CLAREMONT BUSINESS PARK 2 FILING NO. 2

CONSTRUCTION PLANS

TITLE SHEET

NO.	DATE	BY	DESCRIPTION
1	02/14/24	GW	REVISE EL JEFE HEIGHTS ROAD CONNECTION TO GARY WATSON PT

EL JEFE HEIGHTS
 STA 1+00.00 - 7+95.49

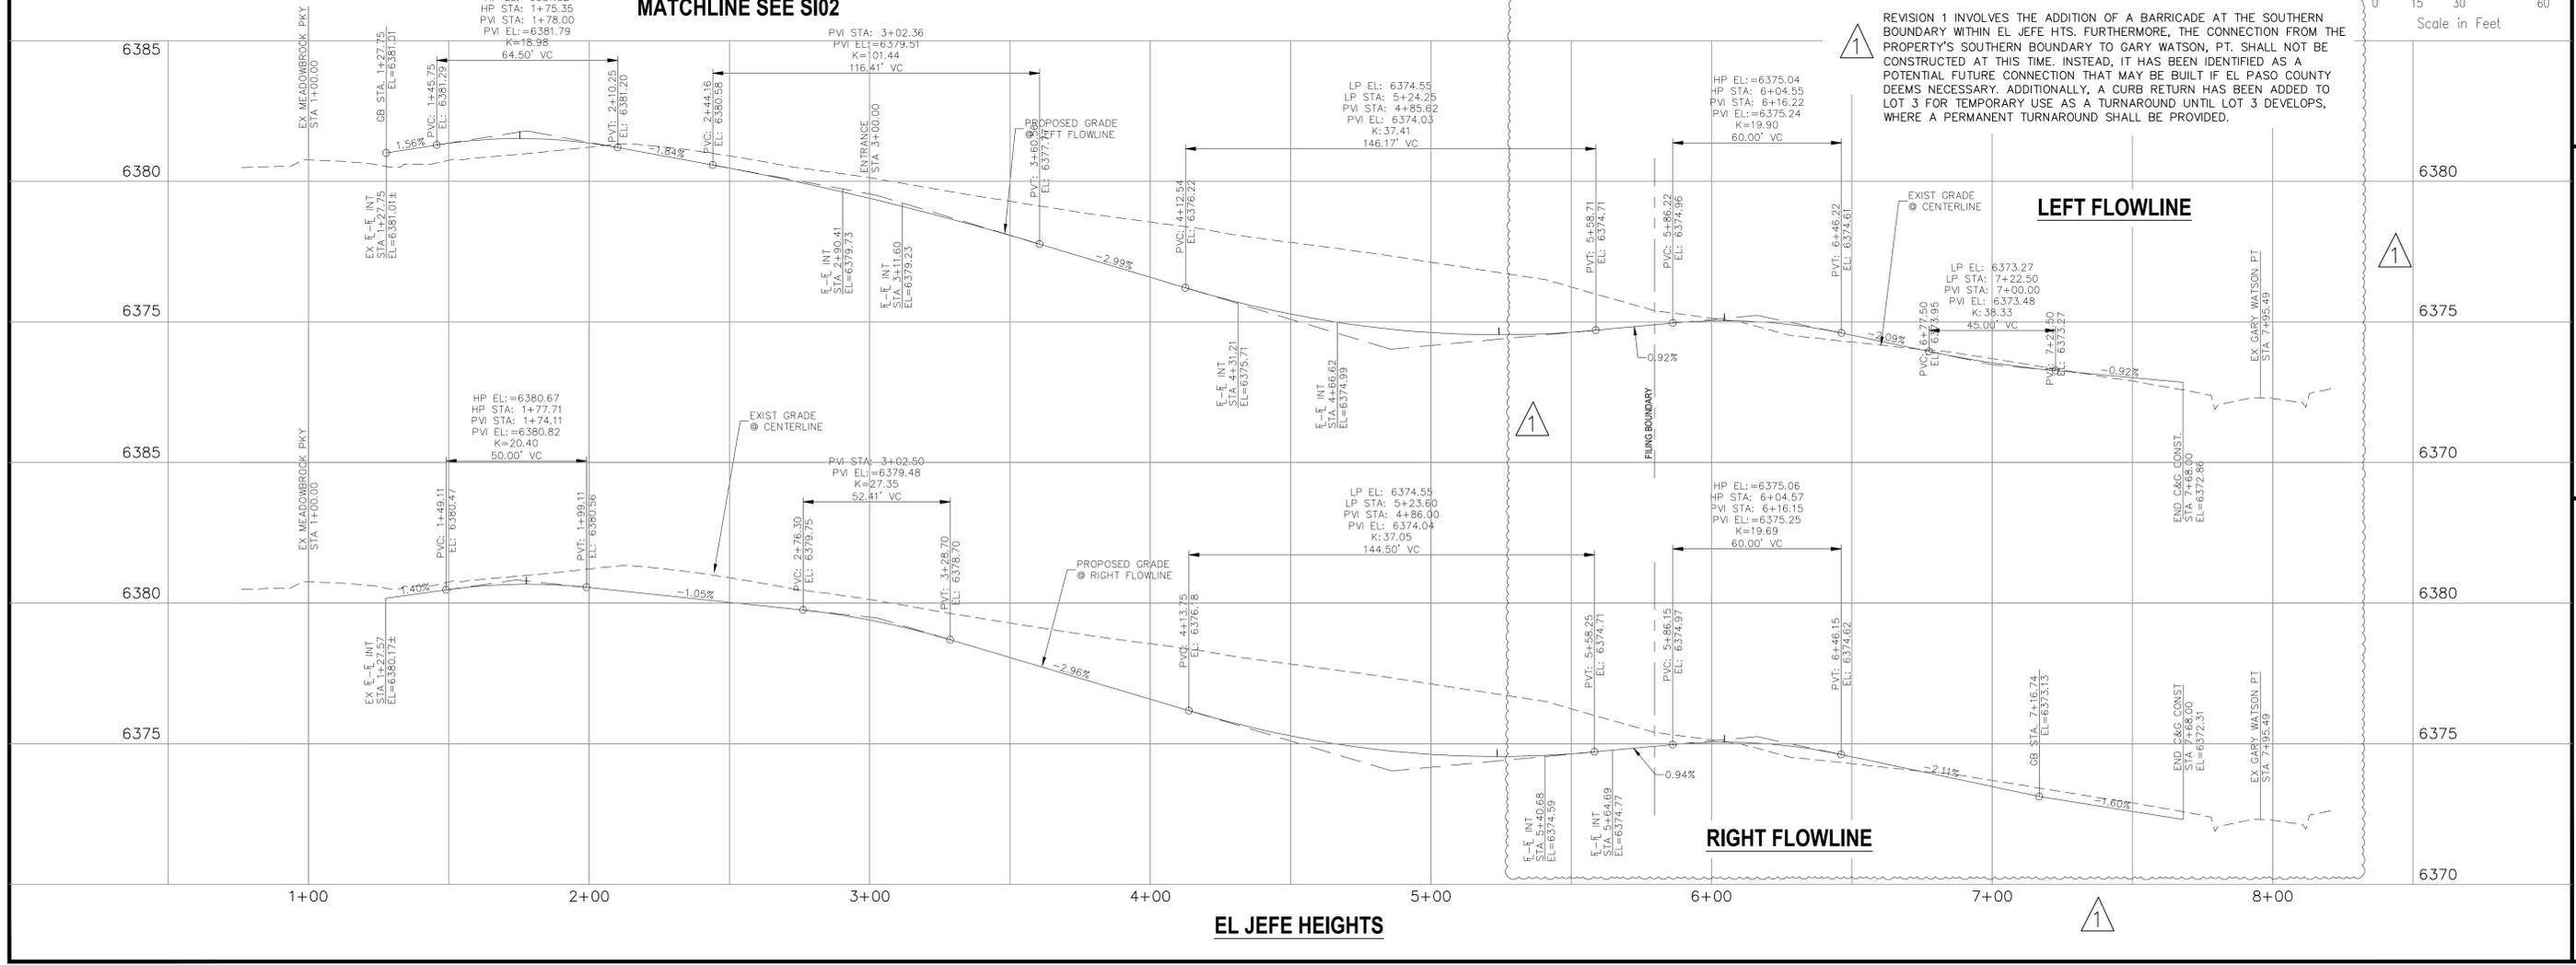
REVISION 1 INVOLVES THE ADDITION OF A BARRICADE AT THE SOUTHERN BOUNDARY WITHIN EL JEFE HTS. FURTHERMORE, THE CONNECTION FROM THE PROPERTY'S SOUTHERN BOUNDARY TO GARY WATSON, PT. SHALL NOT BE CONSTRUCTED AT THIS TIME. INSTEAD, IT HAS BEEN IDENTIFIED AS A POTENTIAL FUTURE CONNECTION THAT MAY BE BUILT IF EL PASO COUNTY DEEMS NECESSARY. ADDITIONALLY, A CURB RETURN HAS BEEN ADDED TO LOT 3 FOR TEMPORARY USE AS A TURNAROUND UNTIL LOT 3 DEVELOPS, WHERE A PERMANENT TURNAROUND SHALL BE PROVIDED.

STORM SEWER PLAN & PROFILE

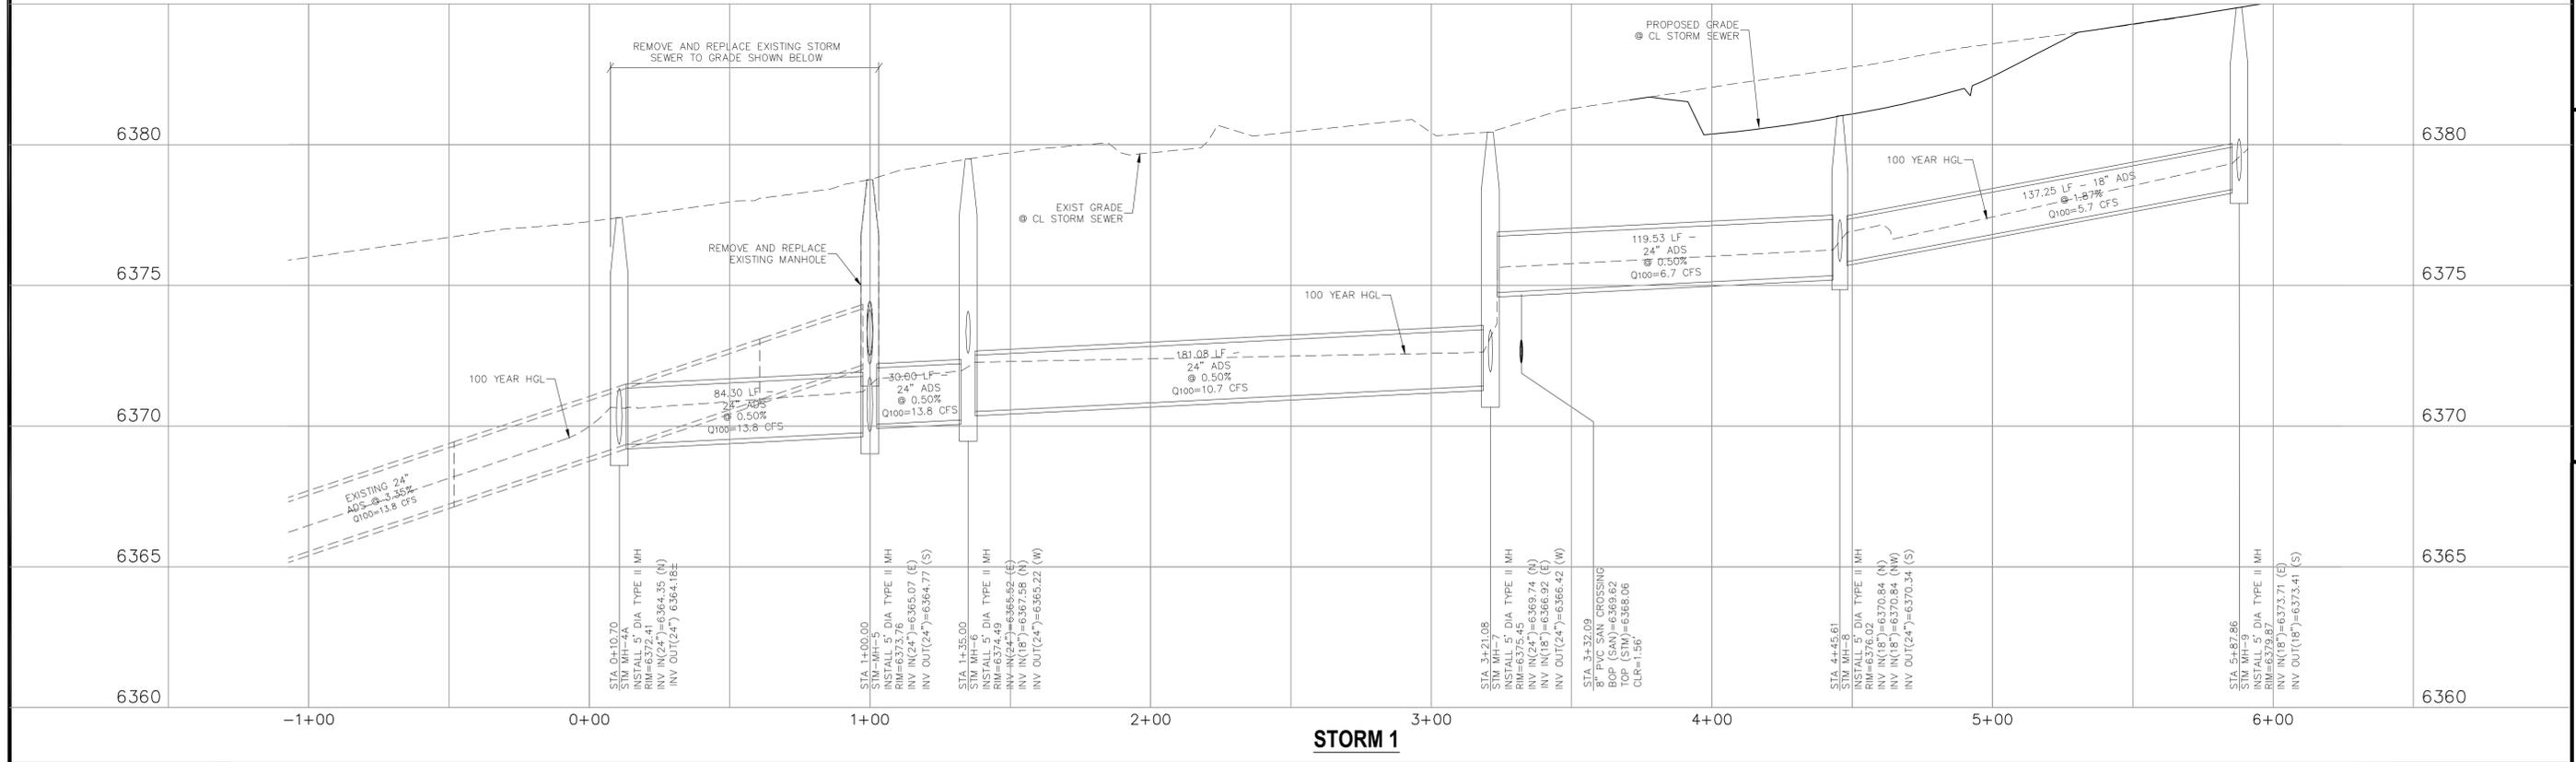
REVISION 1 INVOLVES THE ADDITION OF A BARRICADE AT THE SOUTHERN BOUNDARY WITHIN EL JEFE HTS. FURTHERMORE, THE CONNECTION FROM THE PROPERTY'S SOUTHERN BOUNDARY TO GARY WATSON, PT. SHALL NOT BE CONSTRUCTED AT THIS TIME. INSTEAD, IT HAS BEEN IDENTIFIED AS A POTENTIAL FUTURE CONNECTION THAT MAY BE BUILT IF EL PASO COUNTY DEEMS NECESSARY. ADDITIONALLY, A CURB RETURN HAS BEEN ADDED TO LOT 3 FOR TEMPORARY TURNAROUND UNTIL LOT 3 DEVELOPS, WHERE A PERMANENT TURNAROUND SHALL BE PROVIDED.
